Access Compliance Report

Public Rights-of-Way

(Curb Ramps)

Intersection ID: 7570	Main Street: BEATTIES_FORD_RD	Cross Street: SIR_BAILEY_DR	Location: NW
ADA ID: BCBDE6A6868B	Ramp Type: PerpDiag	Initial Pass/Fail: Fail	Overall Compliance: No
Severity Score: 25			
Codes/Mitigation Info/Possible Solution		Field Measurements/Component Compliance

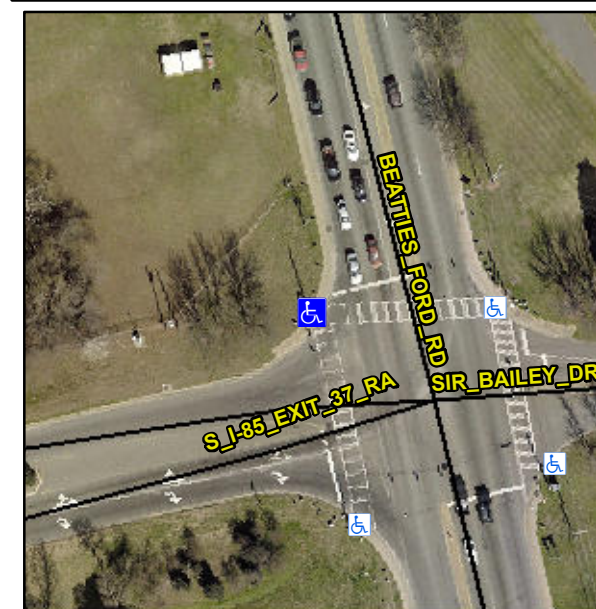
Not Found, R304.2.2

Compliance	Description	Data	Compliance	Description	Data
N/A	Ramp Length (in)	56.0	No	Ramp Slope (%)	12.8
Yes	Ramp Width (in)	48.0	Yes	Ramp XSlope (%)	1.8
N/A	Flare Type LT	N/A	N/A	Flare Type RT	N/A
N/A	Flare Slope LT (%)	N/A	N/A	Flare Slope RT (%)	N/A
N/A	Flare Traversable LT?	N/A	N/A	Flare Traversable RT?	N/A
N/A	Landing Length (in)	N/A	N/A	DWS Provided?	N/A
N/A	Landing Width (in)	N/A	N/A	DWS Contrast?	N/A
N/A	Landing Slope (%)	N/A	N/A	DWS Length (in)	N/A
N/A	Landing X Slope (%)	N/A	N/A	DWS Full Width?	N/A
N/A	Landing Curb? (Y/N)	N/A	N/A	DWS Offset (in)	N/A
N/A	Shared Landing?	N/A			
N/A	Gutter Ponding?	N/A	N/A	Gutter Slope (%)	N/A
N/A	Gutter Lip Ht (in)	N/A	N/A	Gutter X Slope (%)	N/A
N/A	Painted X Walk1?	Yes	N/A	Painted X Walk2?	Yes
	X Walk 1 Direction	To S		X Walk 2 Direction	To E
N/A	X Walk 1 Width (in)	112.0	N/A	X Walk 2 Width (in)	110.0
	X Walk 1 Slope (%)	1.3		X Walk 2 Slope (%)	3.5
	X Walk 1 X Slope (%)	2.5		X Walk 2 X Slope (%)	6.5

Remove & Replace Curb Ramp With Two New Directional Ramps or Equivalent.
